CAMPBELL CITY COUNCIL STUDY SESSION

Subject Study Session – Civic Center Master Plan

Campbell City Hall (Immediate Occupancy)
 70 N. First St, Campbell, CA
 August 22, 2017

Campbell Library (Immediate Occupancy)
 77 Harrison Ave, Campbell, CA
 August 22, 2017

SECOND FLOOR PLAN

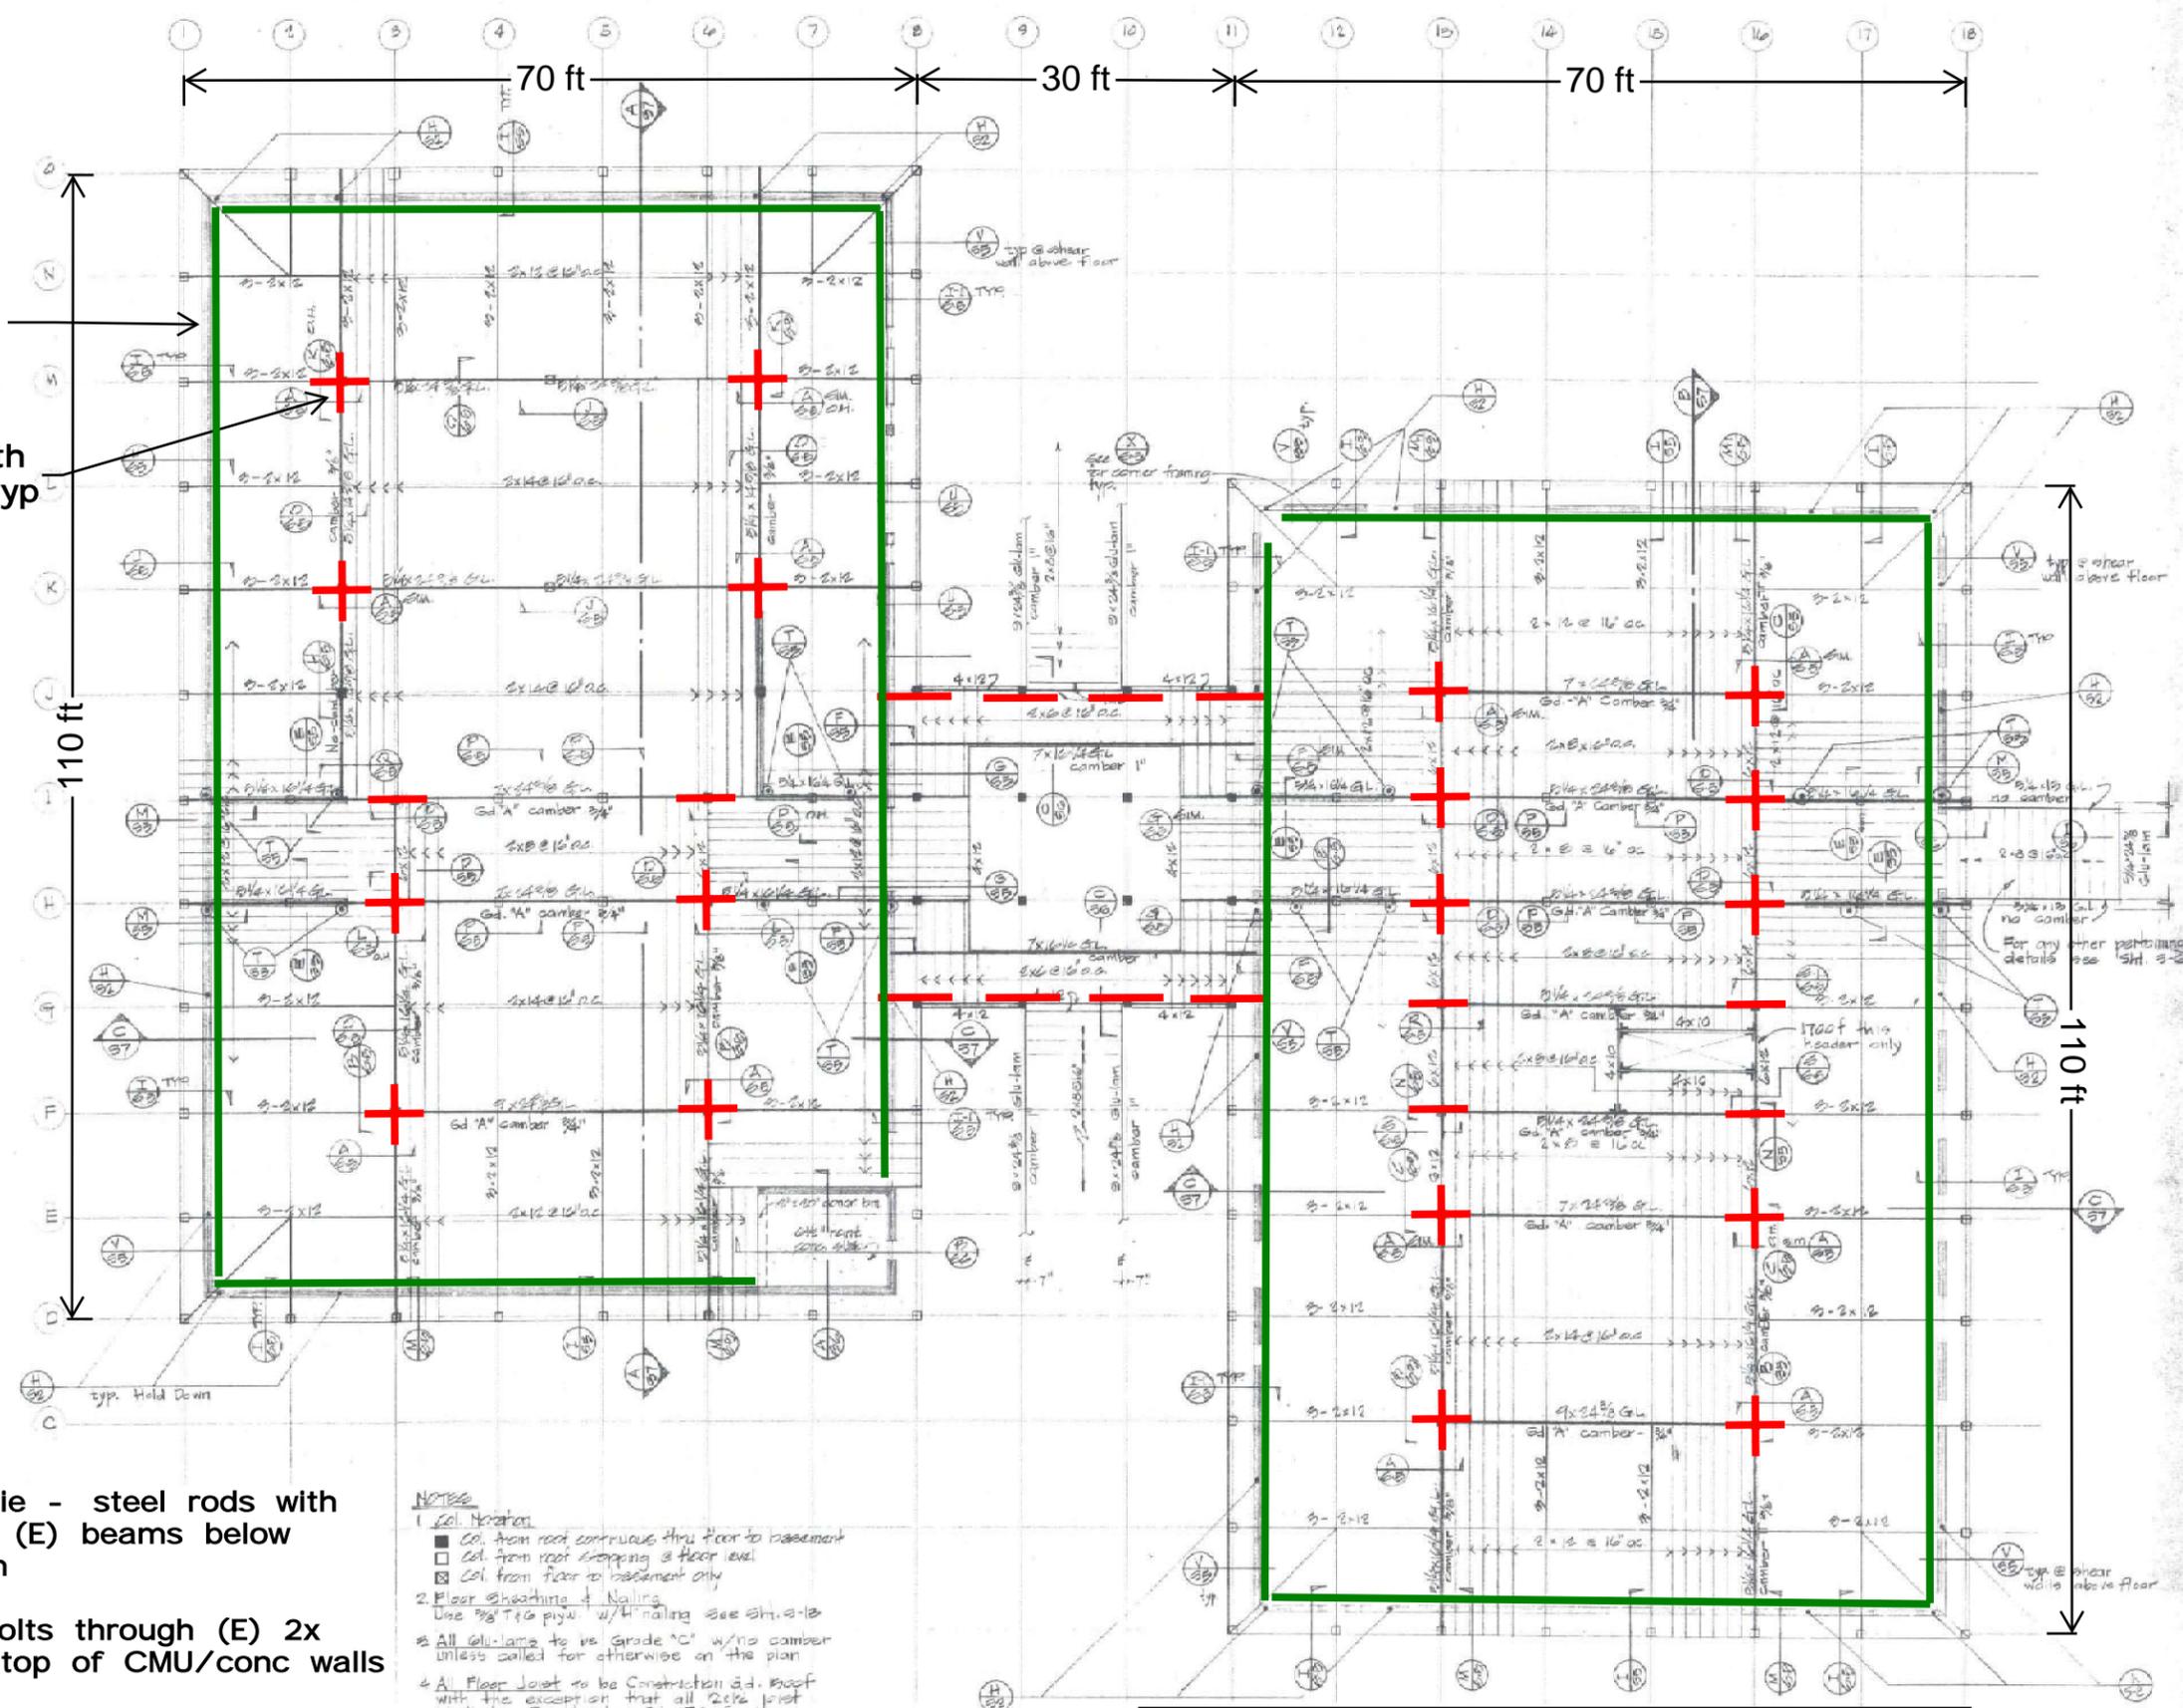
3. At the second floor level, the wood shear walls are inadequate to transfer in-plane seismic loads. Addition of new plywood at the existing shear walls along with steel straps, and steel rods with holdowns is required.
4. At the second floor level, the masonry wall-to-floor connections appear to be inadequate for both in-plane and out-of-plane wall loads. The addition of new anchor bolts will be required.
5. At the high roof level the steel cantilever columns are inadequate for transferring seismic loads into the main roof diaphragm. New infill stud walls with plywood sheathing are required.

1. At low roof level, provide new collectors along shear wall lines by adding new steel straps over plywood sheathing, with new blocking between the joists. [See Deficiency 1 above].
2. At second floor level, provide building cross-ties by adding new horizontal steel straps or steel rods with holdowns at beam splice locations (typically at columns). [See Deficiency 2 above].
3. At second floor level, provide new plywood at several existing shear walls along with new steel straps and steel rods with holdowns. [See Deficiency 3 above].
4. At the second floor level, provide new anchors bolts drilled through the existing wood sill plate and epoxied into the top of the existing masonry walls. [See Deficiency 4 above].
5. At the high roof level, provide several new infill wood stud walls with new plywood sheathing at the clearstory between the low roof diaphragm and high roof diaphragm.

LOWER ROOF PLAN

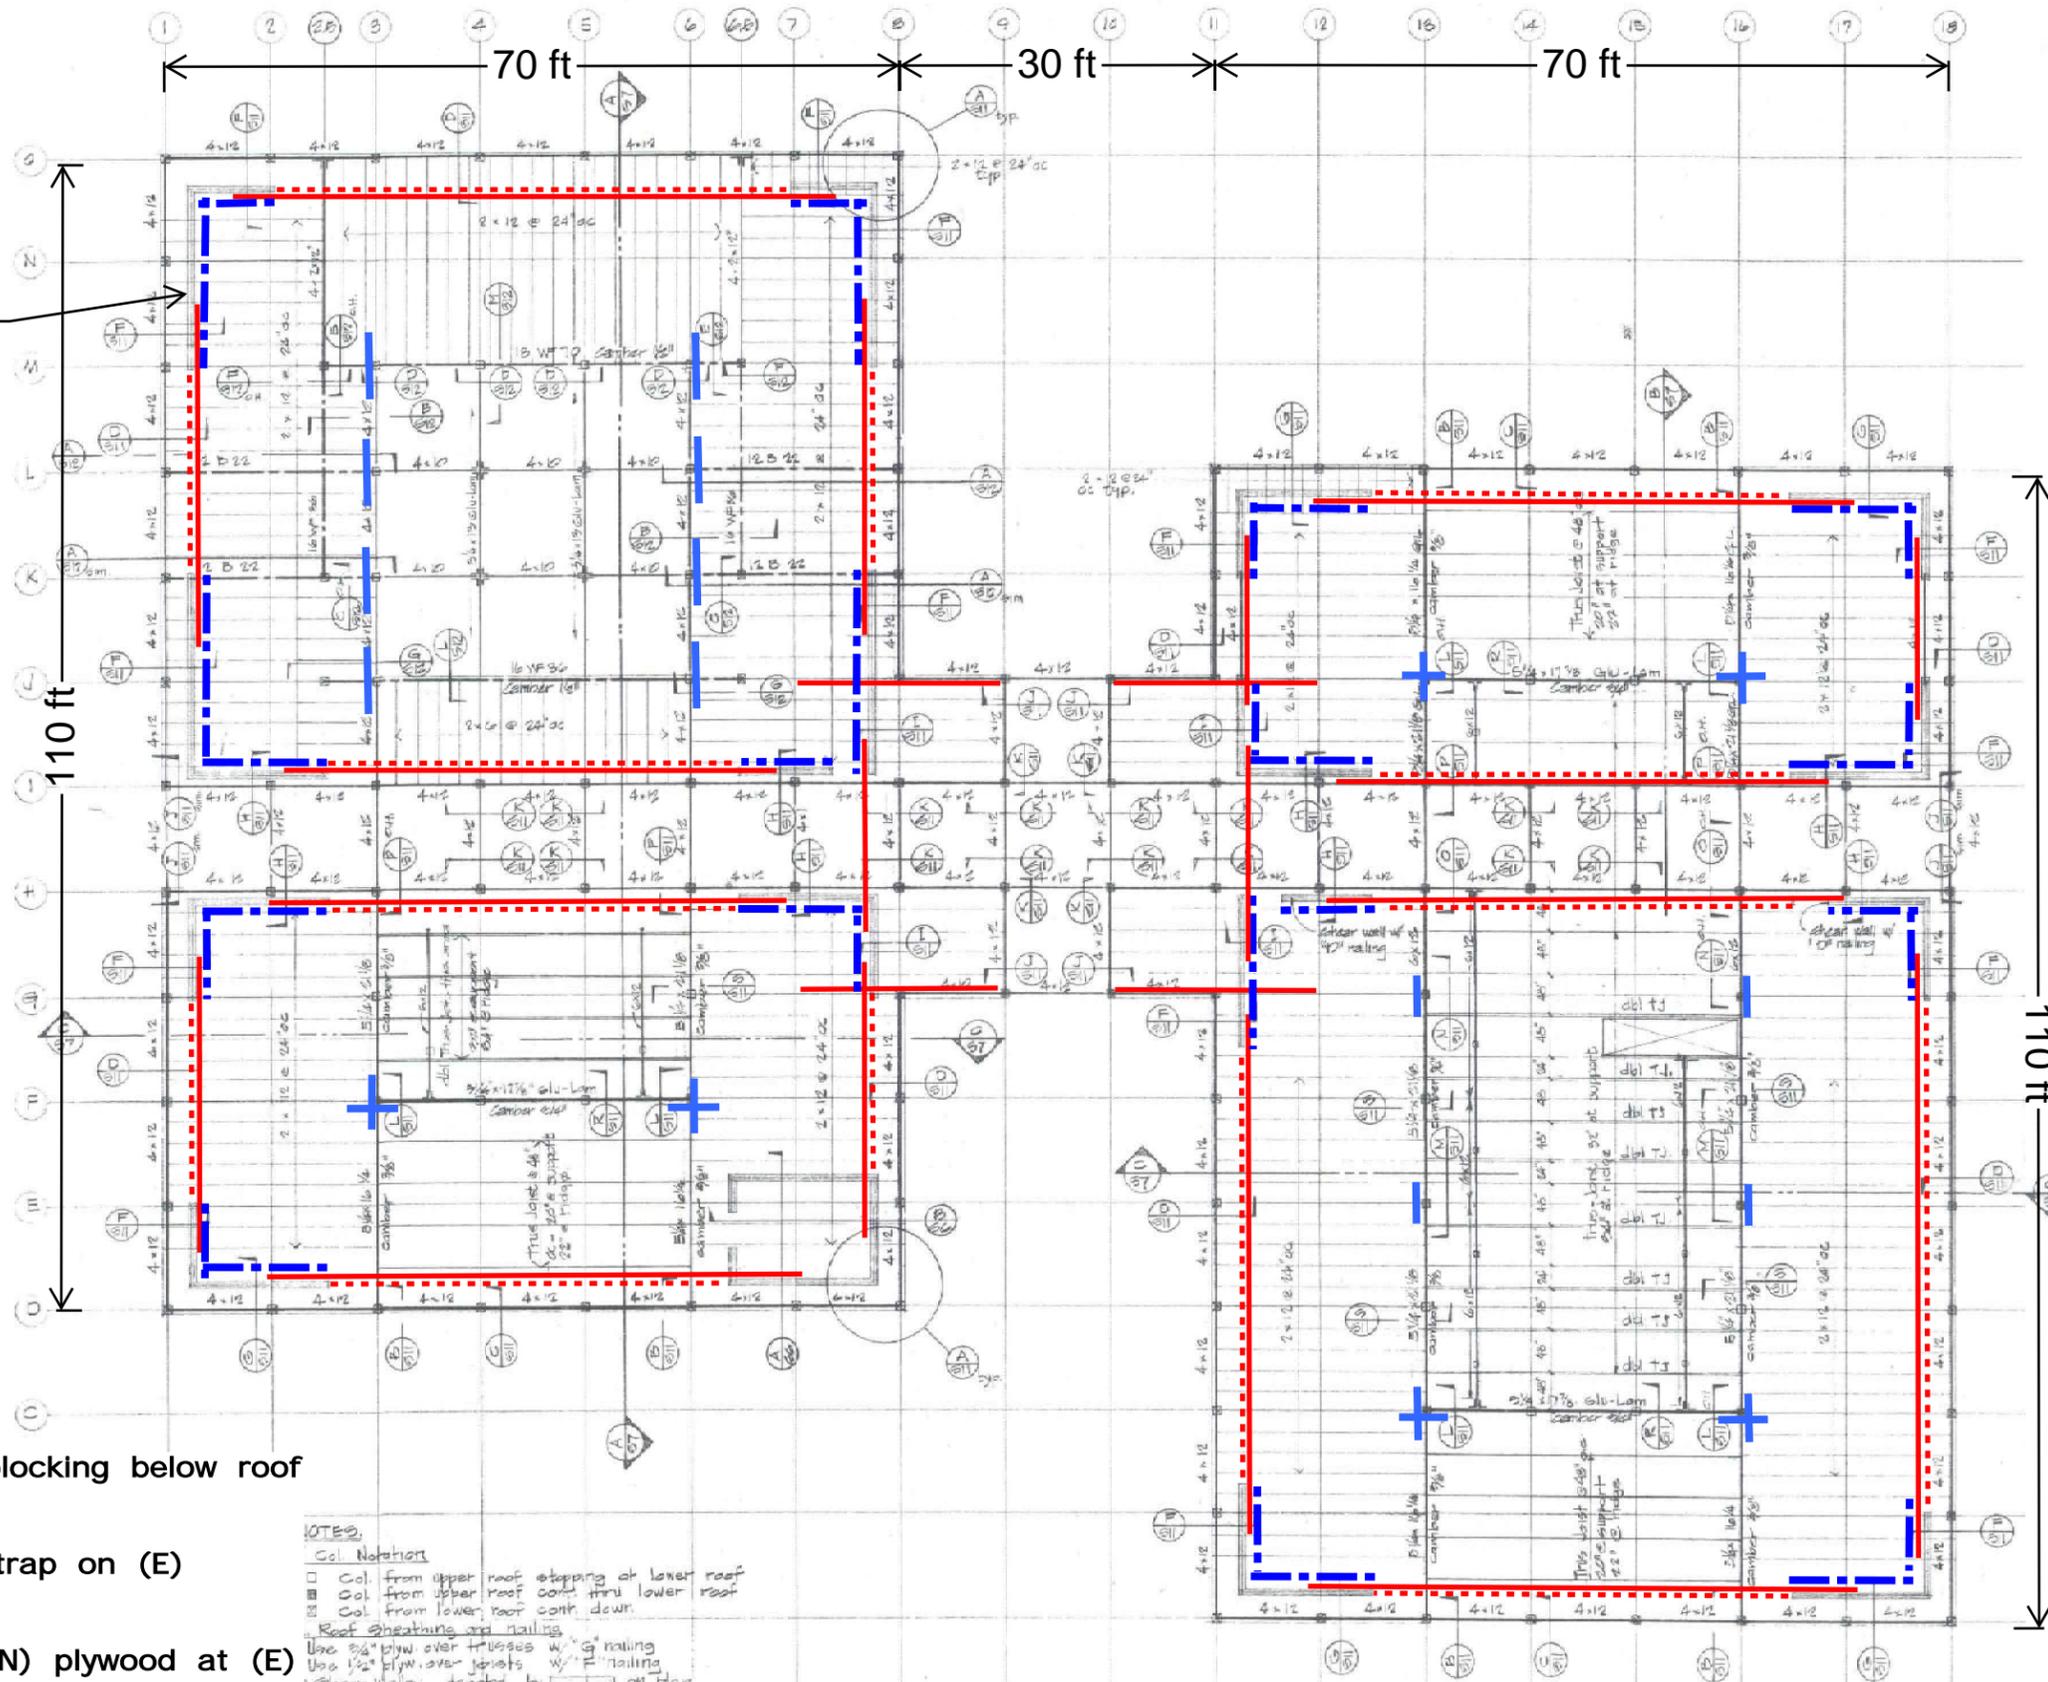
1. At low roof level, collectors along shear wall lines are inadequate for transferring the diaphragm load to the shear walls. Addition of new steel straps with blocking between joists is required.
2. At second floor level, building cross-ties are inadequate for transferring out-of-plane masonry wall loads into the floor diaphragm. Addition of new horizontal steel straps or steel rods with holdowns is required at beam splice locations (typically at columns).

HIGH ROOF PLAN

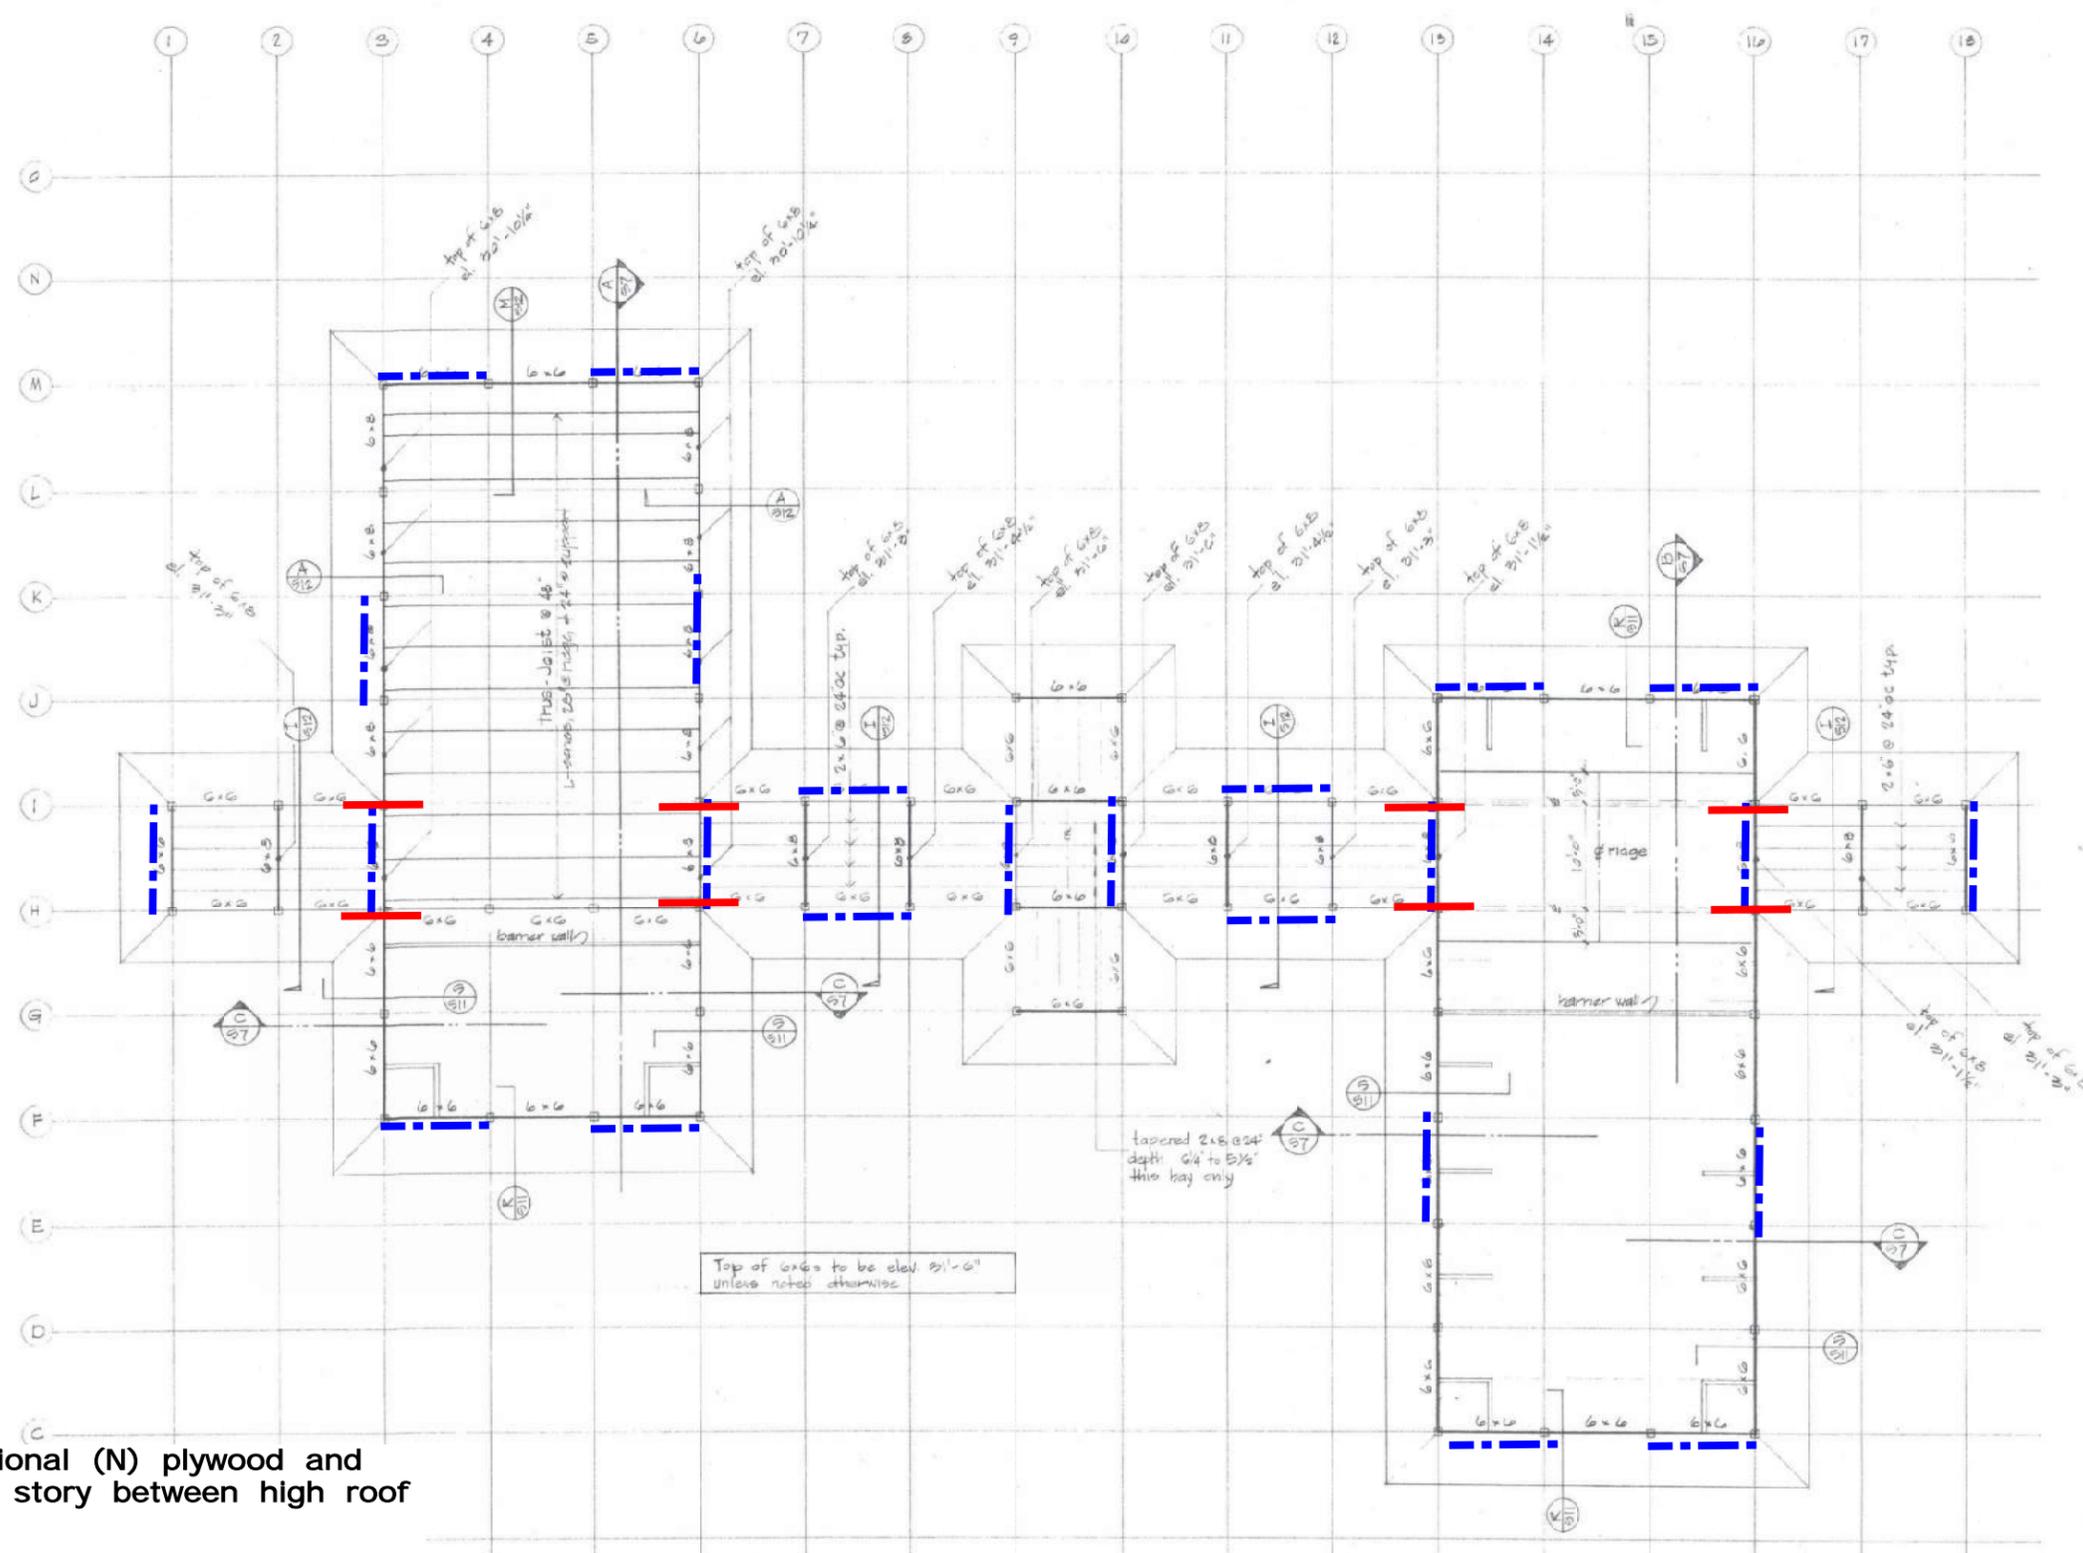
The shear capacities of the roof and second floor plywood diaphragms appear to be adequate for transferring the seismic forces to the shear walls; the details and capacities of the roof diaphragm chords/collectors, however, need strengthening. The steel cantilever columns supporting the high roof appear to be inadequate for transferring the seismic forces into the main roof diaphragm. New lateral elements will need to be added in the clearstory between the high roof and low roof.
